ADDENDUM NO. 1

GMIA – CESSNA SERVICE CENTER APRON RECONSTRUCTION

PROJECT NO. A162-10007

OFFICIAL NOTICE NO. 6892

Sheet C401 Miscellaneous Details: Replace the Doweled Construction Joint detail with the following:

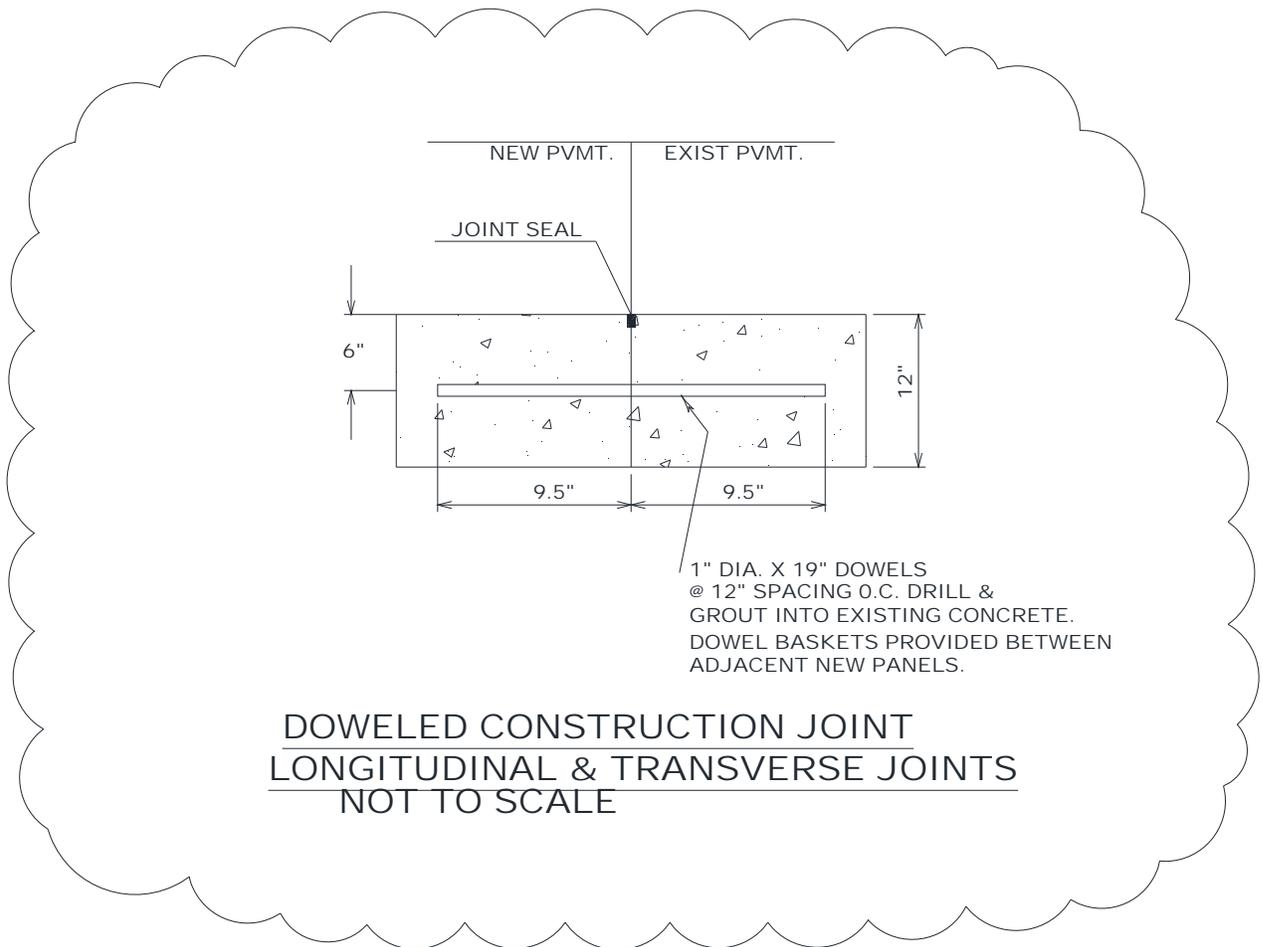
7. Question was raised concerning the 20" C-C spacing of the dowels shown on the details plan sheet.

Answer: The spacing is erroneous. The C-C spacing of the 1" diameter dowels is **12 inches** (see attached revised detail).

CONSTRUCTION BARRIER DETAIL

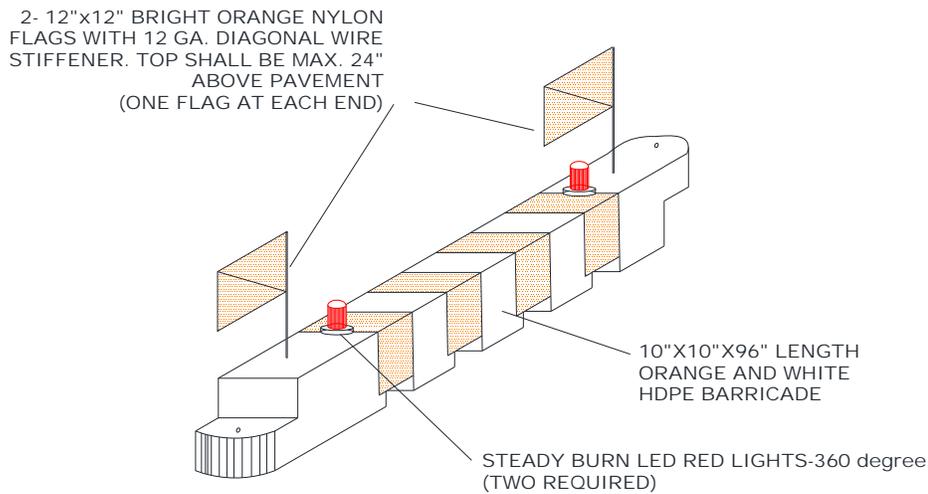
8. No detail shown for the low-profile barricades.

Sheet C401 Miscellaneous Details: Add the following detail to the sheet:

Answer: See attached detail for low-profile barricade.

1. TYPICAL BARRIER TO BE PLACED ALONG THE LIMITS OF THE PHASES OF WORK, AS SHOWN IN THESE PLANS, TO DELINEATE THE CONTRACTOR'S WORK AREAS.
2. BARRIER SECTIONS SHALL BE WHITE WITH ORANGE STRIPES.
3. ALL BARRIERS SHALL BE CHECKED VISUALLY FOR SIGNS OF WEAR AND TEAR ON A WEEKLY BASIS AND REPLACED AS NEEDED.
4. ALL LIGHT FIXTURES SHALL BE VERIFIED OPERATIONAL BY CONTRACTOR DAILY.
CONTRACTOR MUST HAVE A PERSON ON CALL FOR 24 HOURS A DAY FOR EMERGENCY MAINTENANCE OF AIRPORT HAZARD LIGHTING AND BARRICADES.
5. COST OF INSTALLATION AND MAINTENANCE OF BARRIERS SHALL BE INCLUDED IN M-101 MOBILIZATION.
6. BARRIERS SHALL BE PLACED END TO END WITH DESIGNATED GAPS FOR VEHICLE TRAFFIC.
7. NO PART OF THE BARRIER SHALL EXCEED 24" IN HEIGHT FROM THE PAVEMENT.
